Planning Commission Meeting Work Session
September 14, 2026 @ 6:30 PM
This meeting is recorded for public record.

West Chester Borough Planning Commission (PC) Meeting Minutes
Voting Meeting
August 10, 2026
6:30 PM

COVER SHEET FOR
TRBL WALNUT, LLC
615 & 617 S. WALNUT STREET
WEST CHESTER, PA 19382
WEST CHESTER BOROUGH • CHESTER COUNTY • PENNSYLVANIA

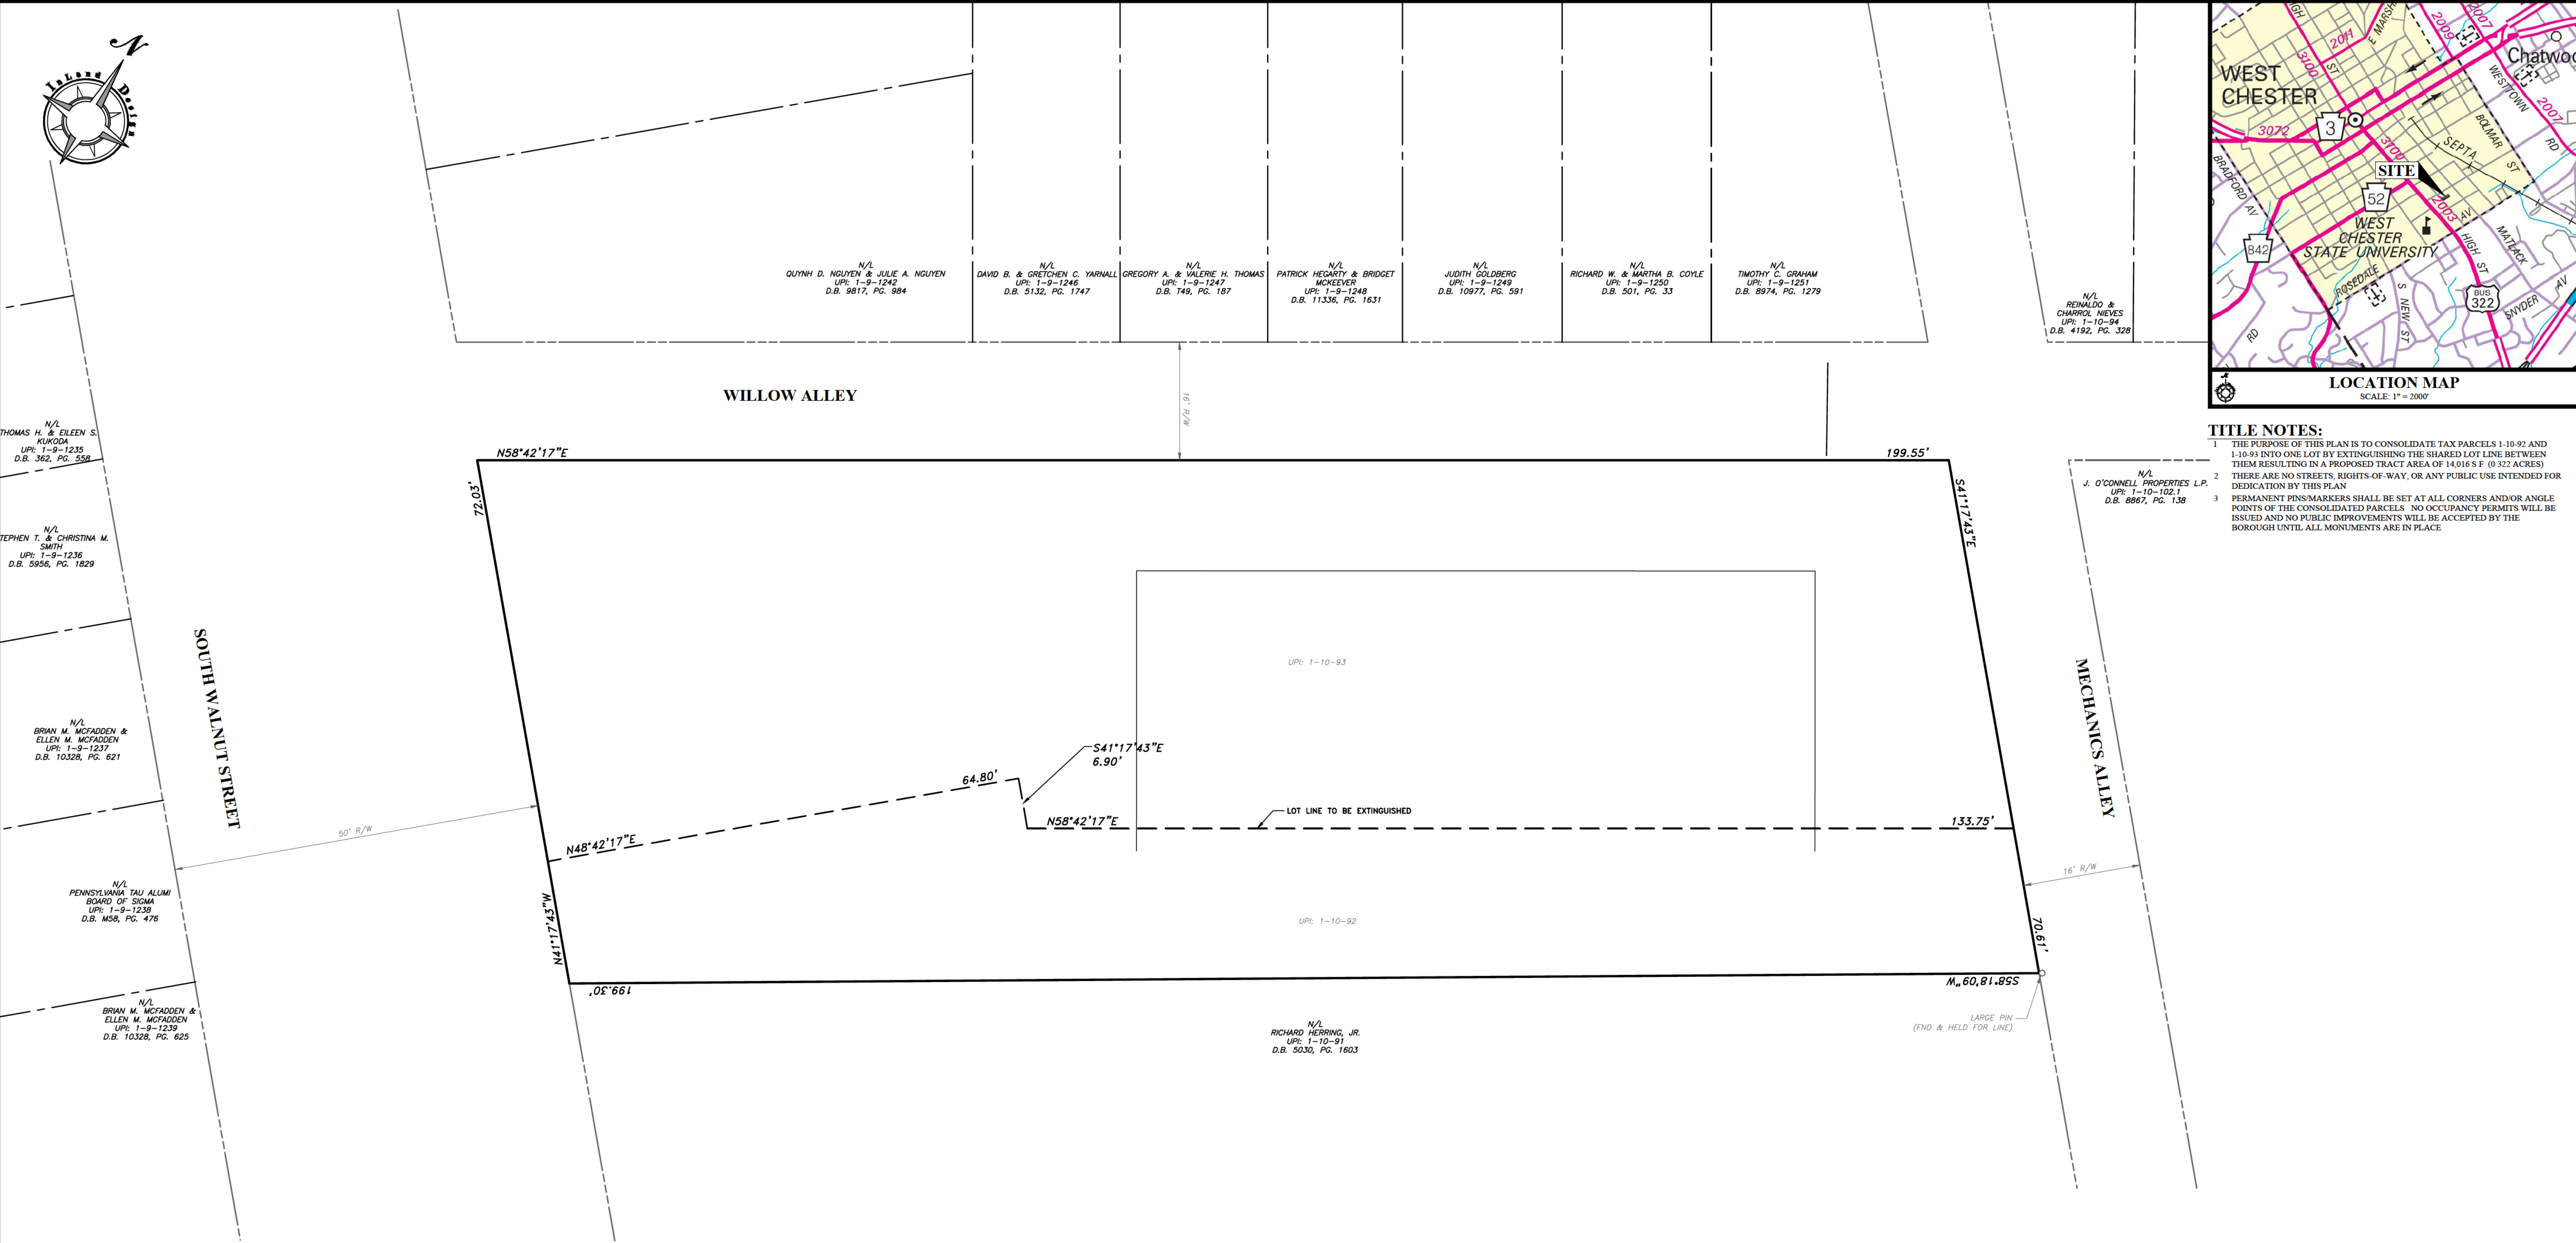
Pending. General Note No. 26 has been added to Sheet 1 indicating the additional off-street parking spaces shall be restricted to the existing twin dwellings. Defer to Borough Solicitor/HOA documents.

Outstanding. *General Note No. 25 has been added to Sheet 1 indicating that the new units will have a basement bathroom that utilizes a sewer pump that will pump into the building's internal*

Resolved. General Note No. 25 has been added to Sheet 1 indicating that the new units will have a basement bathroom that utilizes a sewer pump that will pump into the building's internal gravity plumbing before the gravity sewer leaves the building.

EXISTING CONDITIONS & DEMOLITION PLAN
FOR
TRBL WALNUT, LLC
615 & 617 S. WALNUT STREET
WEST CHESTER, PA 19382
WEST CHESTER BOROUGH • CHESTER COUNTY • PENNSYLVANIA

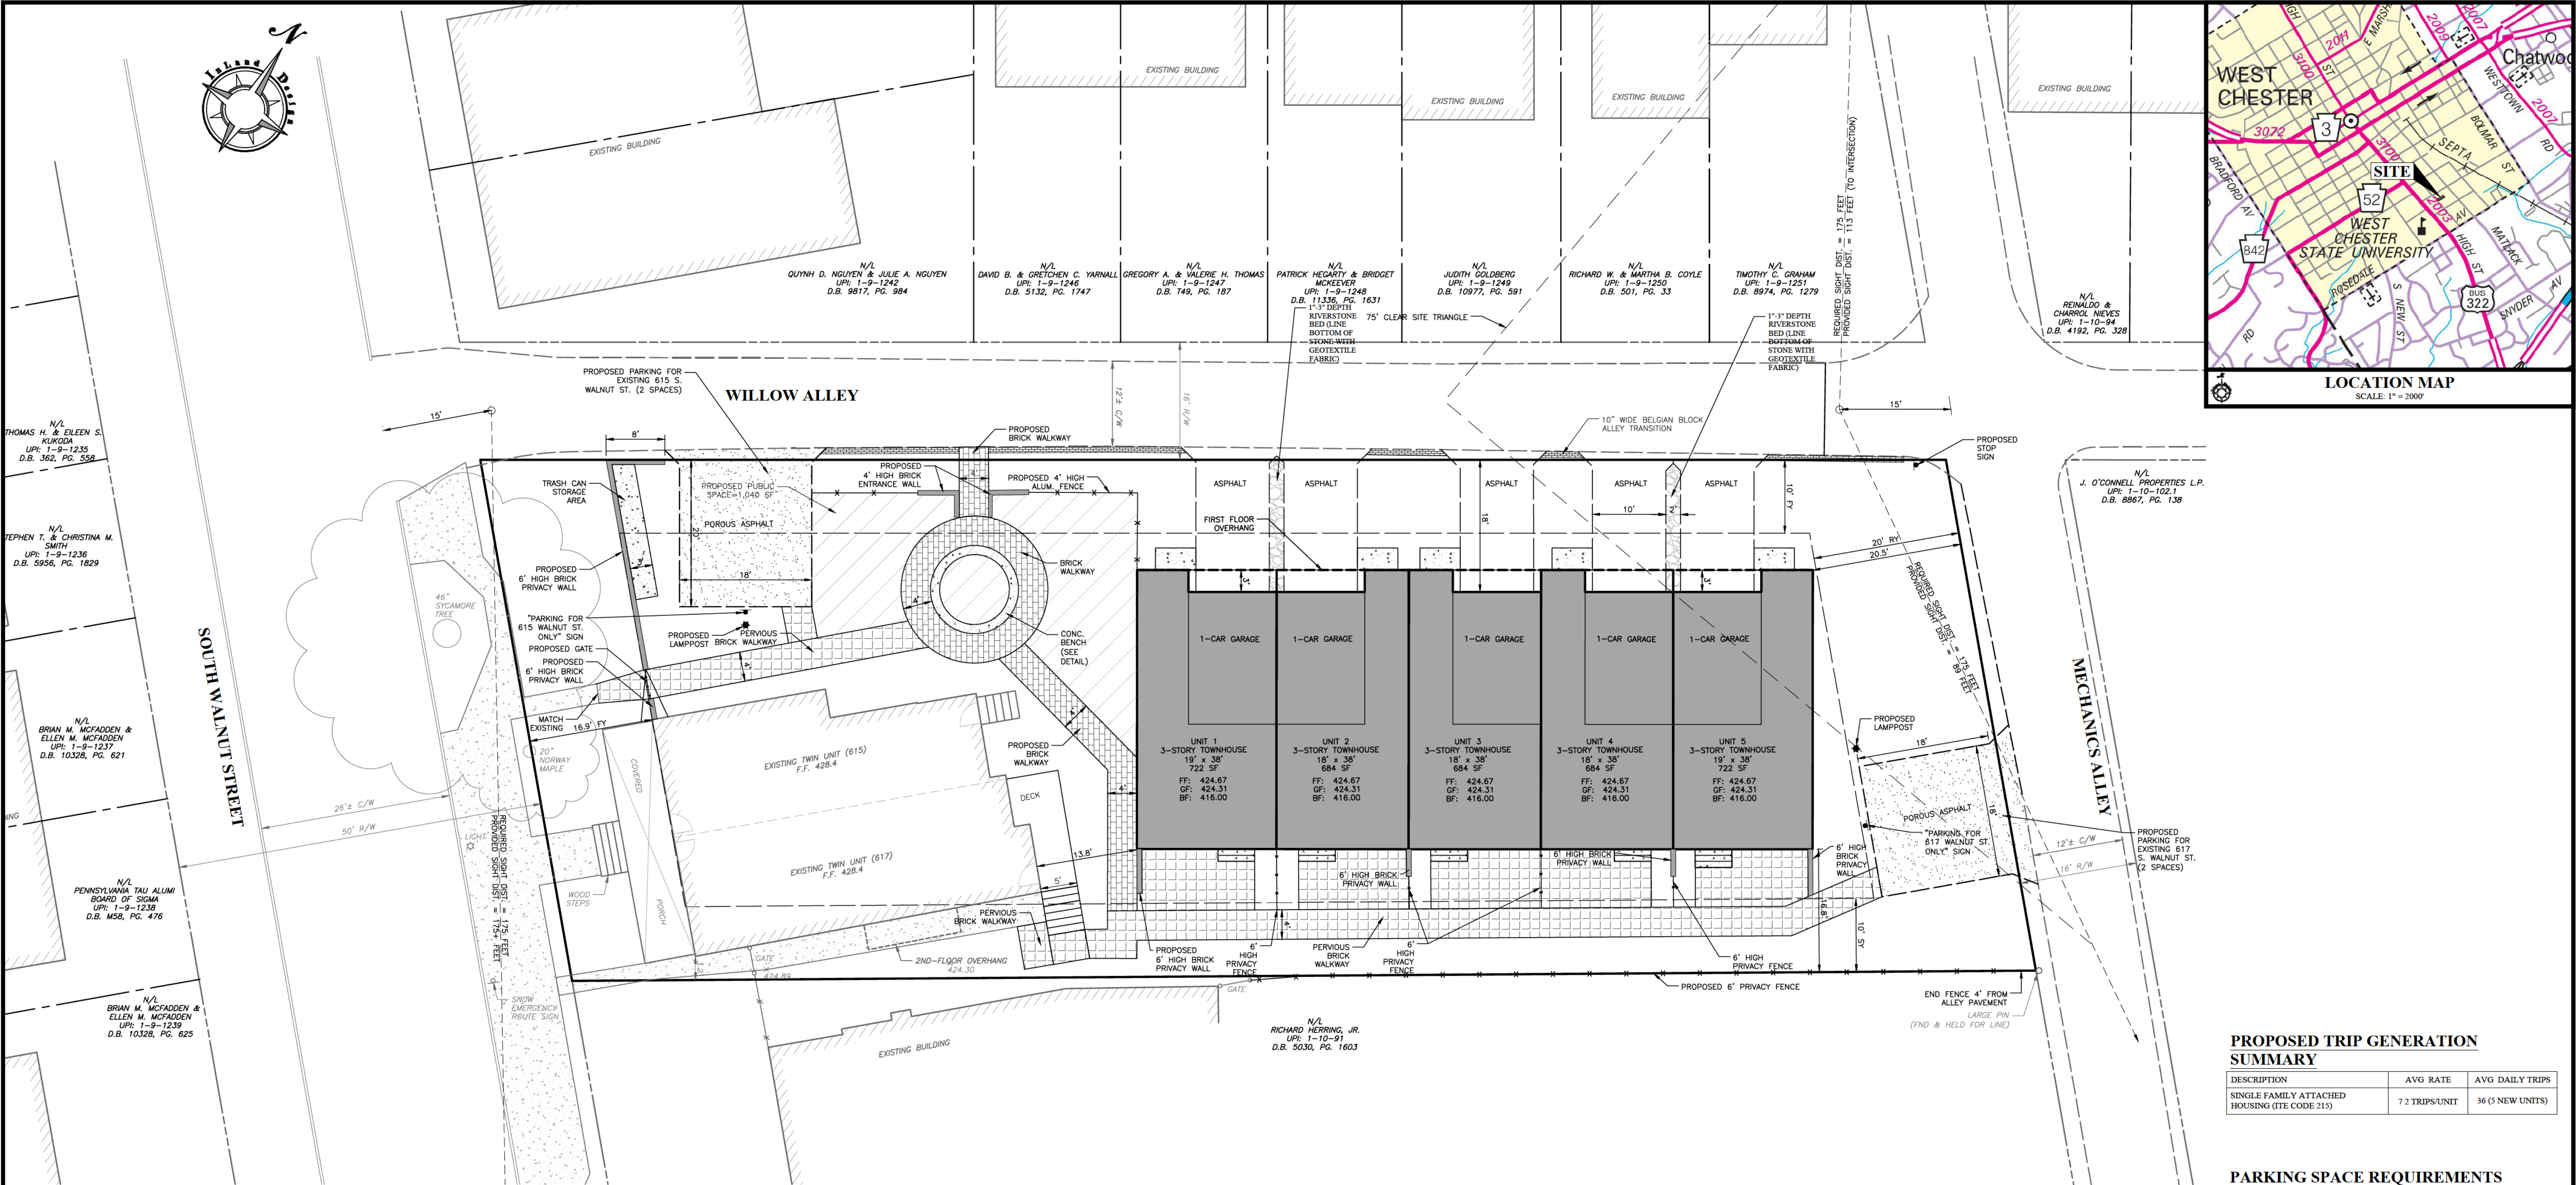
Resolved. Demolition Note No. 3 on Sheet 3 indicates that the sewer lateral in Mechanics Alley shall be cut and capped at the sewer main.

Resolved. Demolition Note No. 4 on Sheet 3 has been added.

Resolved. A "Median Lot Area Calculation" table has been provided (Sheet 3).

LAYOUT PLAN FOR
TRBL WALNUT, LLC
615 & 617 S. WALNUT STREET
WEST CHESTER, PA 19382
WEST CHESTER BOROUGH • CHESTER COUNTY • PENNSYLVANIA

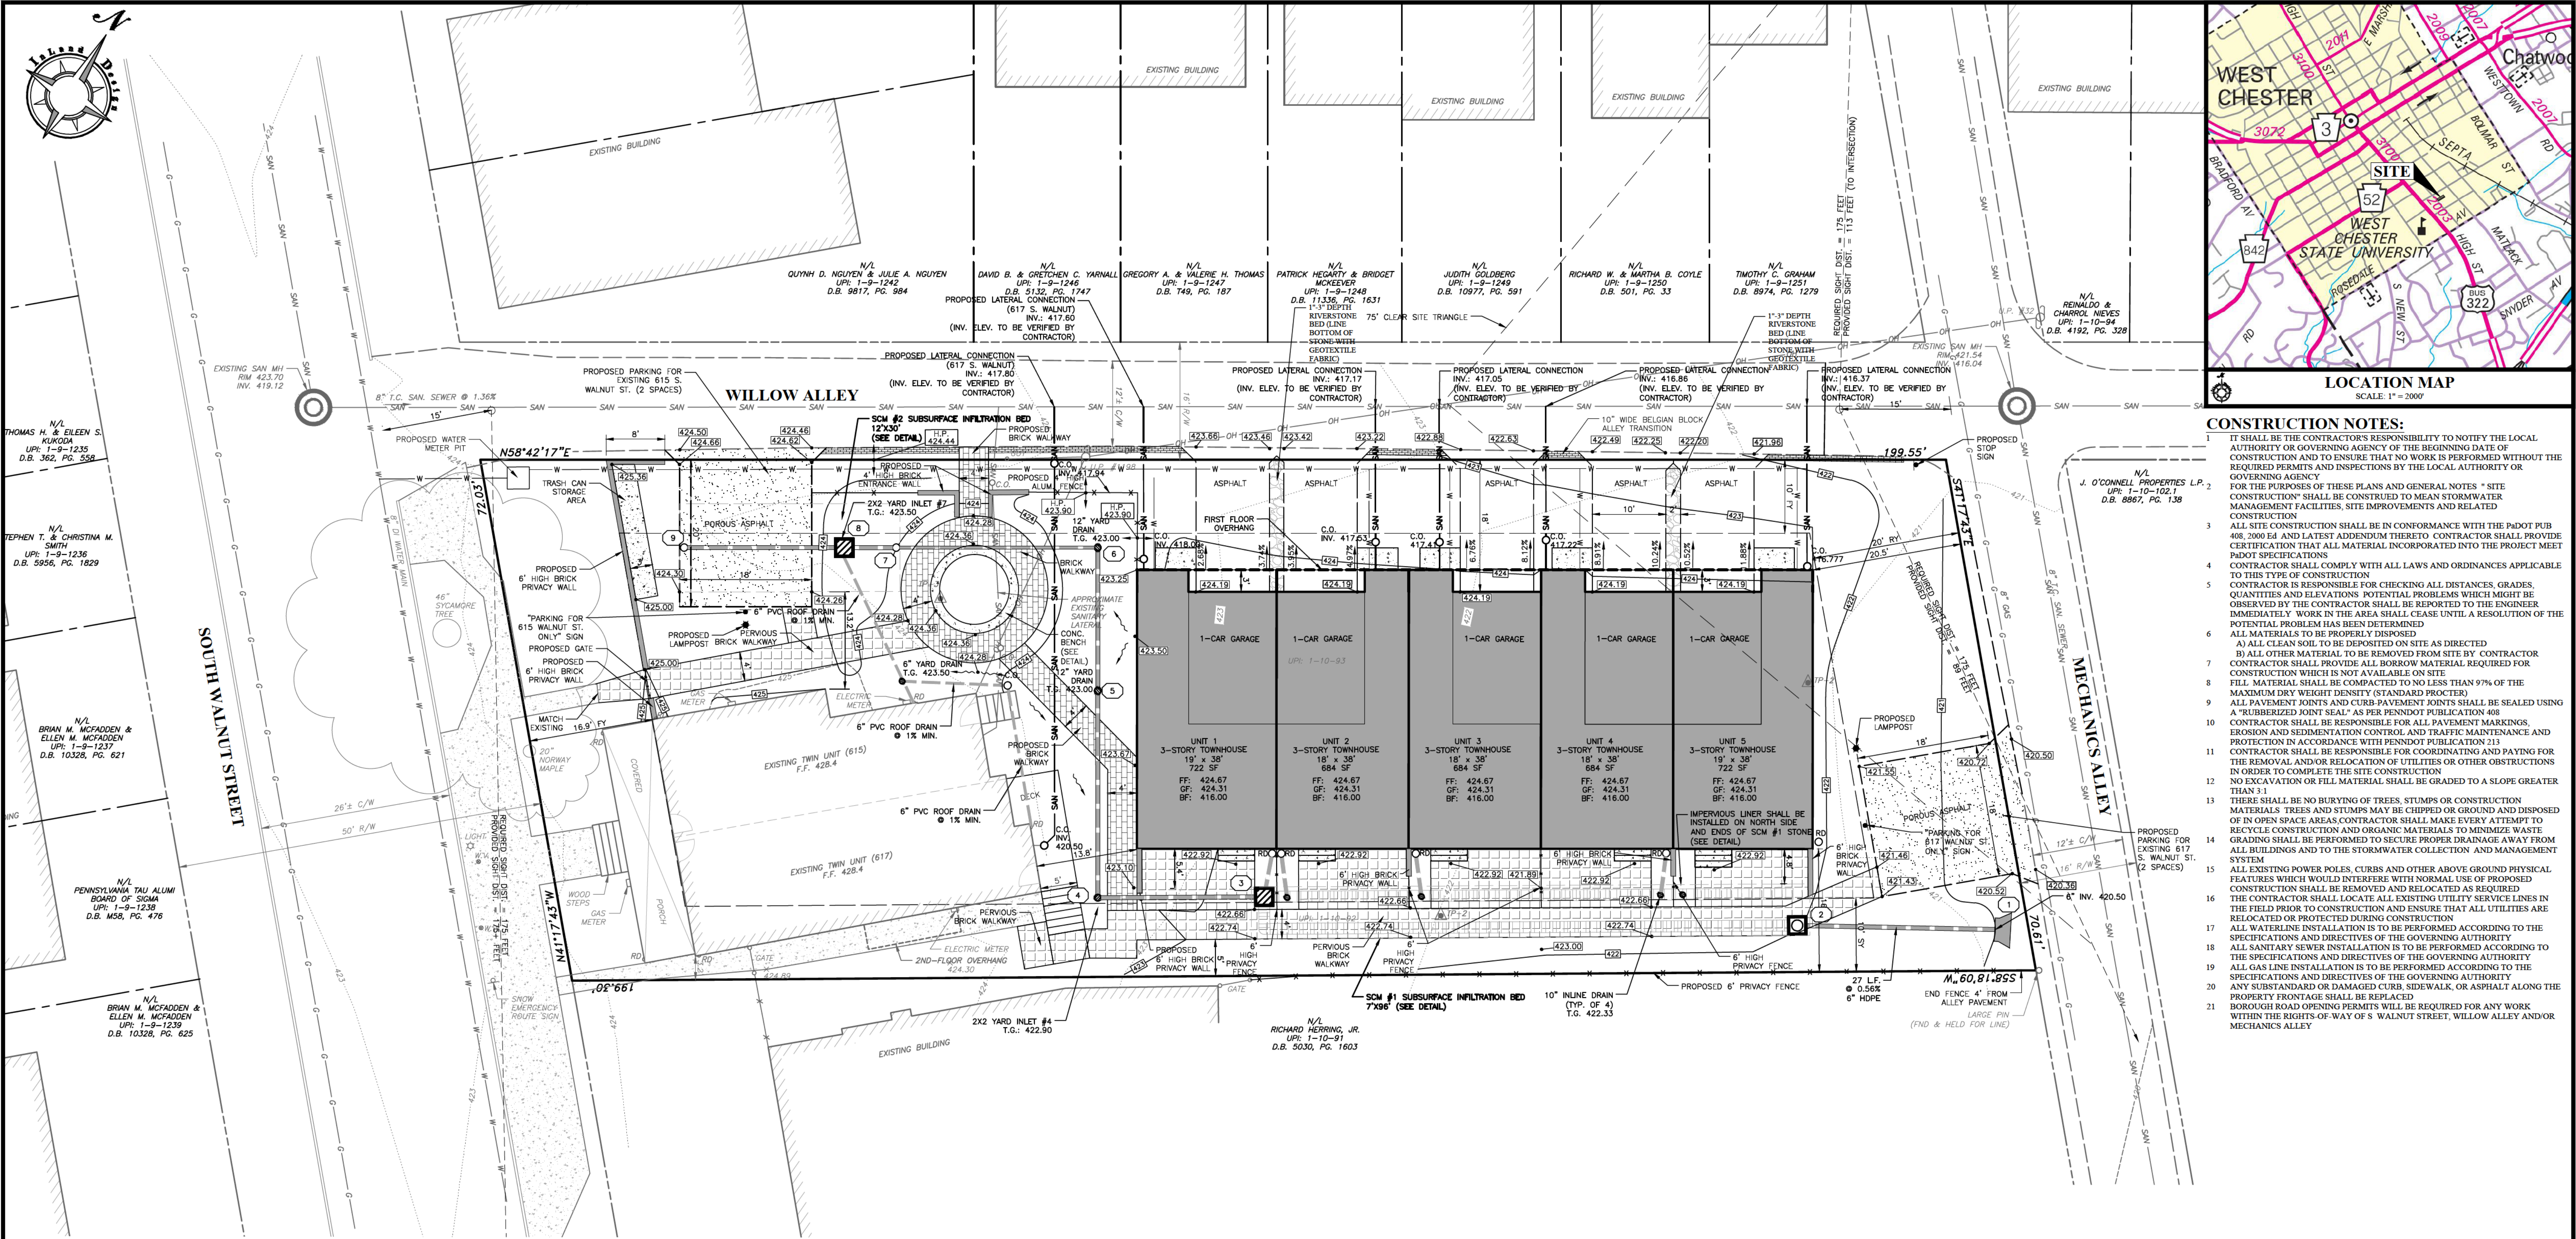
2. Sheet 4 of the Land Development plans indicates there is a proposed 3' concrete sidewalk adjacent to a proposed 6' high brick wall on the northwest corner of the development. Please identify the intent of the sidewalk. Additionally, please note per §97.A.20.3 that all sidewalks are to be designed to a minimum width of 4-feet. **Response: The proposed sidewalk tapers to a 3' width to connect to the existing sidewalk width. We are not proposing widening in this location so we do not disturb the existing heritage tree's roots. Clarify the 3' wide proposed sidewalk behind the 6' brick privacy wall, west of the parking spaces for 615 S. Walnut Street. It appears to be disconnected from any other walkway.**

3. Sheet 4 of the Land Development plans indicate two (2) off-street parking areas. Please note if these spaces are proposed for the existing units. If so, please indicate if these spaces will be reserved for these units or open to the public. **Response: The spaces are intended to provide parking for the existing units (two for each unit). Labels stating this have been added to the Layout Plan sheet and General Notes #26 has been added to the plan. Provide detail on how these spaces are to be reserved for the existing units.**

6. Indicate details for the proposed fence along the southern border of the proposed site. The proposed fence shall not restrict the required 175-feet of intersection sight distance looking right from Willow Alley at Mechanics Alley. **Response: The sight distance has been revised on the plan (see response to comment #7). Also the referenced fence layout has been revised end perpendicular to the alley and not wrap around corner. Clarify whether the southern border fence will be the 4' powder coated aluminum fence or the 6' vinyl privacy fence as shown on Sheet 14. Clarify the fence layout as it is not clear where the fence terminates along Mechanics Alley.**

8. Provide stop signs for the Willow Alley approaches with the additional trips projected to access this alley. **Response: The plans have been revised to show a proposed stop sign at the Willow Alley and Mechanics Alley intersection. A trip generation chart has been added to the Layout Plan, Sheet #4. Please provide a stop sign detail to be shown on Sheet 14.**

Resolved. A detailed calculation of proposed impervious coverage has been added (Sheet 4).

Resolved. A detailed calculation of the proposed building coverage has been added (Sheet 4).
